| Project | IEEE 802.16 Broadband Wireless Access Working Group < <u>http://ieee802.org/16</u> > | | |
|------------------------------------|--|--|--|
| Title | Action items from Session #44 | | |
| Re: | Working Group Review of Working Document 802.16h-06/015r1 | | |
| Abstract | This document contains a resolution of action items assigned during Session #44. | | |

Figure 1 Flowchart showing generic operation in bands with specific spectrum users.

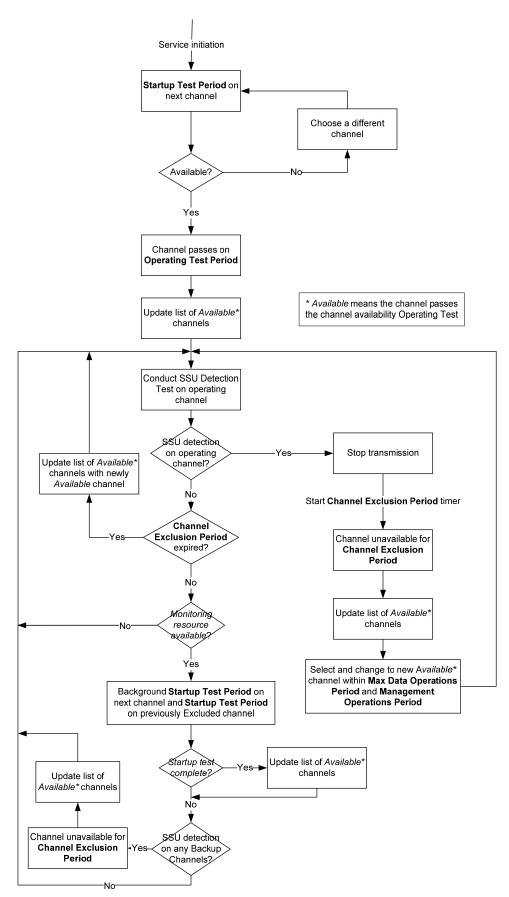
3. Correction to figure h1 in 6.3.15 [1]

Replace the new paragraph as the end of 6.3.15.1 with the following:

Figure 1 below provides a replacement figure for Figure h1 in sub clause 6.3.15.1.

Figure h1 provides an illustrative flowchart of a generic scheme for operation in bands with SSUs. The flowchart highlights the main operational requirements for coexistence and overviews the description in the remainder of this sub clause.

Figure h2 – Representation of *ChannelCentreFrequency* calculation.

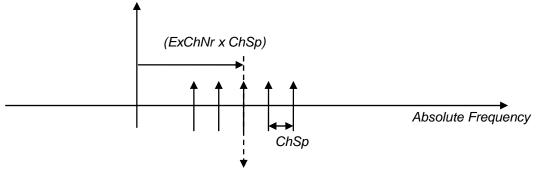
Replace 6.4.1.2 with the following

Extended channel numbering provides an enhancement to the definition for *channel center frequency* given in section 8.5.1. This extension provides channel references beyond the limitations of 5-6GHz as defined in that section. The channel references are described according to the following terms.

- Extended Channel Number (ExChNr) A 2 byte specific channel number reference in MHz. ExChNr is a logical channel number within a given band and enables the absolute frequency to be calculated with the use of a 2 byte reference.
- Base Channel Reference (*BaseChRef*) A 1 byte base reference to frequency range or deployment band in MHz. *BaseChRef* is an index into a list of known operational bands, termed *BaseCenterFrequency()*. For a given value of *BaseChRef* then *BaseCenterFrequency()* provides the lowest, or base, center frequency for a particular band of operation.
- Channel spacing (ChSp) A 2 byte channel spacing value in 10kHz increments. The channel spacing is referenced from center frequency to center frequency.

The terms above are used to calculate the physical *channel center frequency*, termed *ChannelCenterFrequency*, and is defined accordingly:

ChannelCentreFrequency [MHz] = *BaseCenterFrequency*(*BaseChRef*) [MHz] + (*ExChNr* *(*ChSp**0.01)) [MHz] [xxx]
